REVIEW OF THE INDIAN POINT PROBABILISTIC SAFETY STUDY

Consultants to the Advisory Committee on Reactor Safeguards

Review Performed Over the Period
June to September 1982

Figure C4-1. Exponential Fits of Fire Diameter Complementary Cumulative Distribution Function.

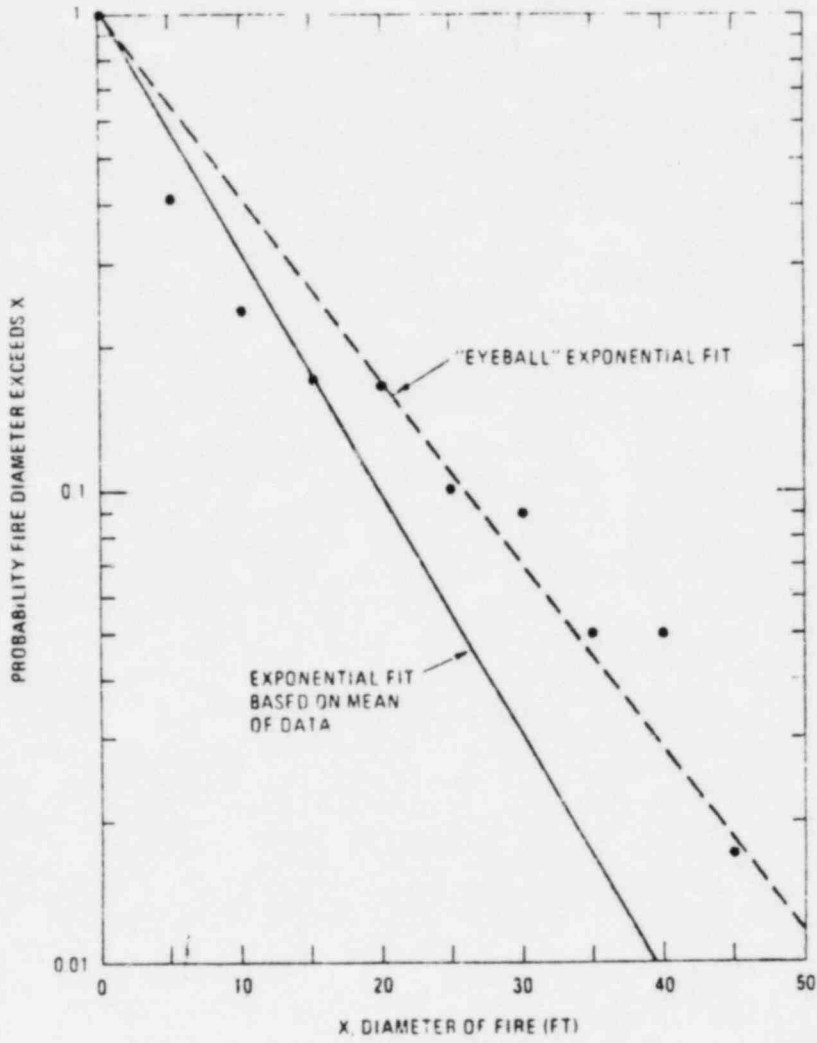
- 2) Fleming, et al., Ref. CR3, reviewed the available data on fires and presented the complimentary cumulative distribution as a function of fire diameter. This graph is reproduced in Fig. C4.1. The horizontal cross section of the cable spreading room in Indian Point 2 is 8 ft high, 10 ft wide. One classification of a large fire is fires whose fire diameter is greater than a characteristic length of the room, say 10 ft. Approximately 25% of the fires experienced the damage diameter exceeding 10 ft. How does this compare with the distribution chosen.
